From: Scala, Mary Joy
Sent: Tuesday, April 22, 2014 2:06 PM
To: 'valaw1126@comcast.net'; David Kariel (dkariel@cstone.net)
Subject: BAR Action April 15, 2014 - 632 Ridge Street

RE: 632 Ridge Street
Main house maintenance and upgrades; cottage renovation

**CITY OF CHARLOTTESVILLE
BOARD OF ARCHITECTURAL REVIEW
STAFF REPORT
April 15, 2014**

BAR 14-04-05
632 Ridge Street
Tax parcel 250064000
Red Rose, LLC, Owner/ Otis Lee, Jr, Applicant
Main house maintenance and upgrades; cottage renovation

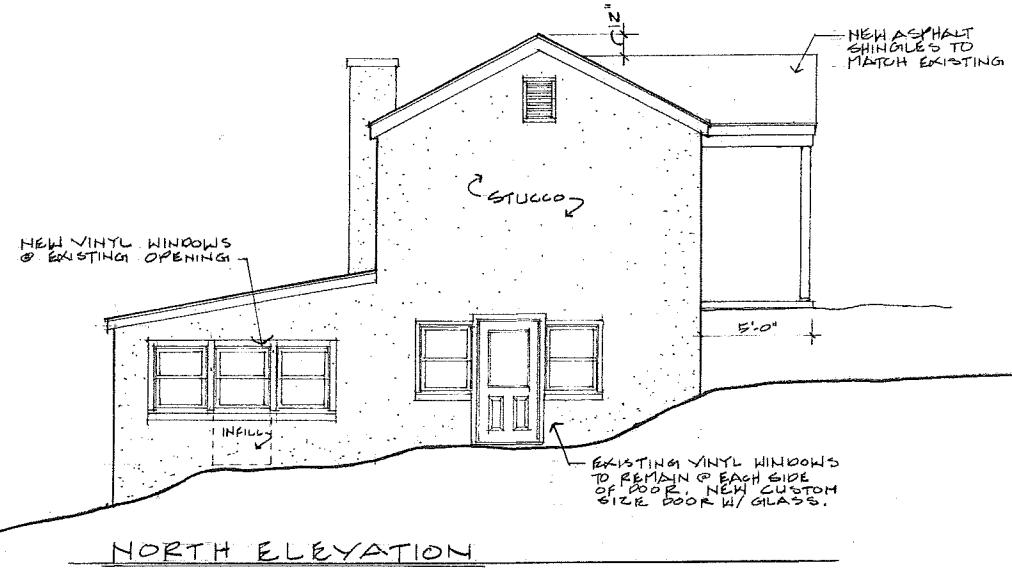
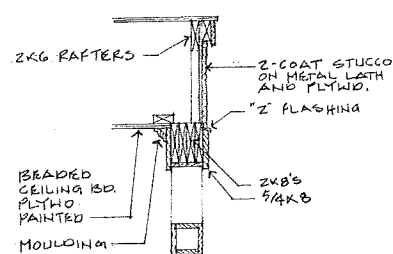
Approved (7-0) as submitted, but address the utility meter area by cleaning up the extra plywood, and putting a simple wood sloped roof over it and painting it all medium gray; and retain/repair as much as possible the cottage windows (rather than replacing them.)

2012 walkway approval

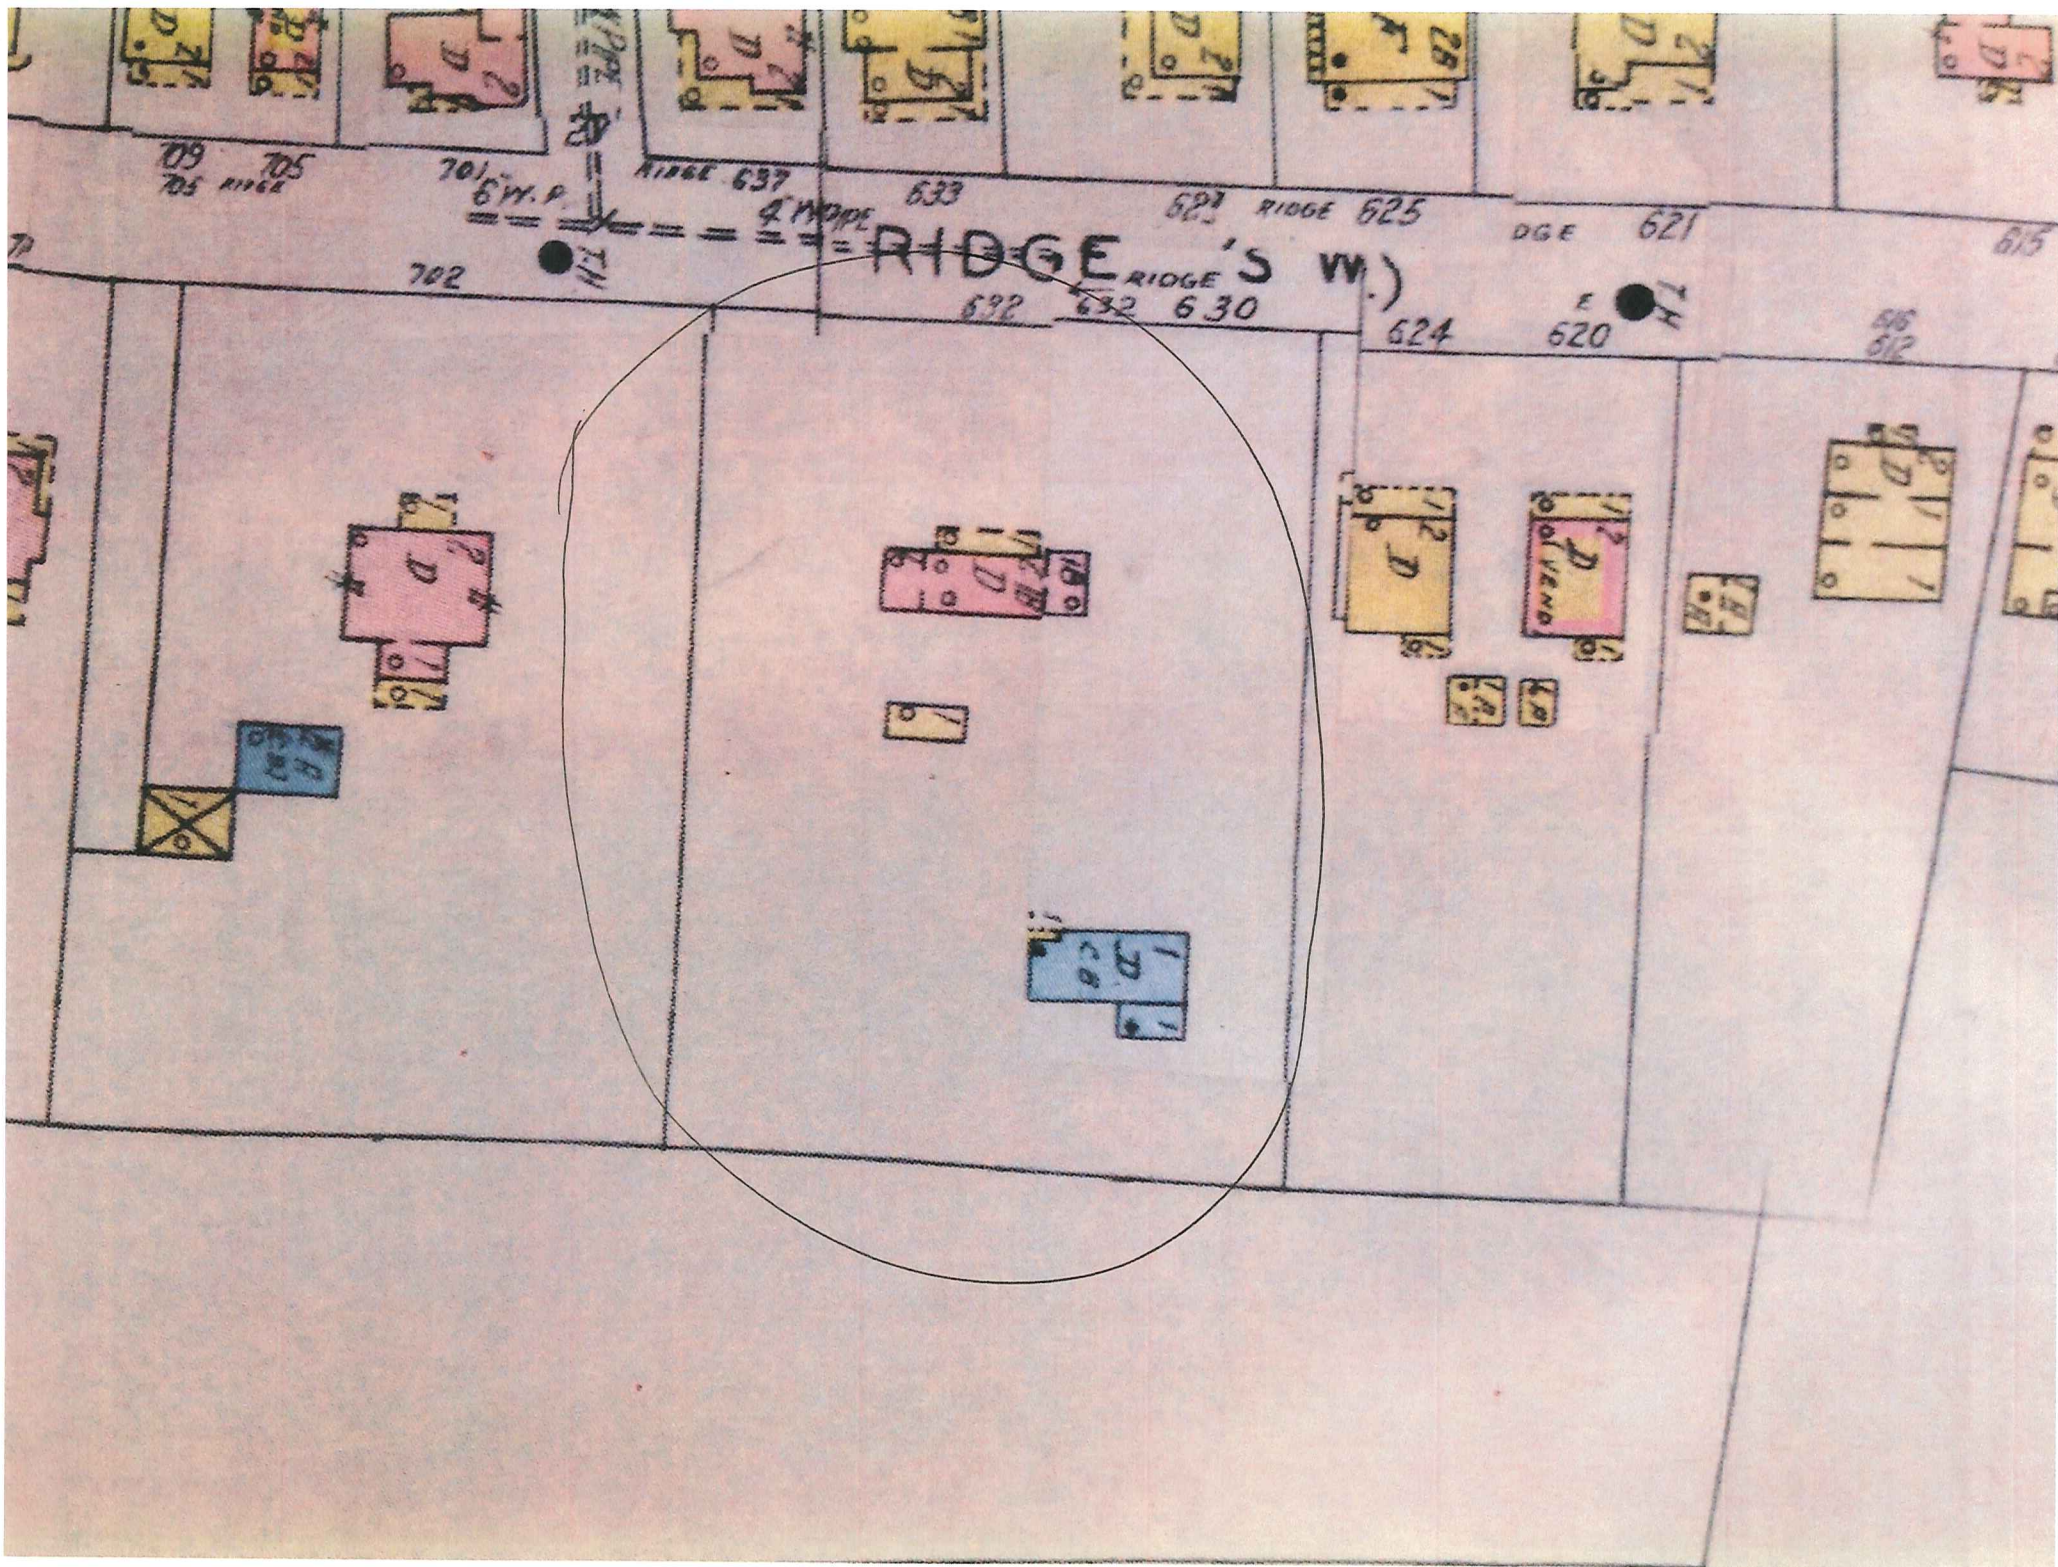
- 1) The walkway width and material should be specified.
The walkway will be 5' wide "city mix" concrete consistent with typical City spec.
- 2) The landscaping materials should be specified.
Landscaping materials are more clearly specified on the attached landscape exhibit.
- 3) No lighting is shown, but the BAR may want to see the fixture type.
The applicant has not yet decided whether this walkway will be lit or unlit. The applicant requests that the BAR approve lighting fixtures consistent with the attached lighting spec sheet. The specified fixture is dark-sky compliant. Should the applicant decide to provide lighting, this fixture will be installed in accordance with a comprehensive lighting plan that meets City ordinance submitted to NDS with the final site plan.

I hope this is what you were looking for. I made the walk 5' wide as the 4' shown by Dominion seems too narrow to me. The trees selected are Kentucky Coffee Trees (*Gymnocladus dioica*) and they are spaced 28' OC with the opposing row staggered 14'. I am showing liriopse in the bed below the trees feeling that shrubs will obstruct visibility and may be deemed less safe.
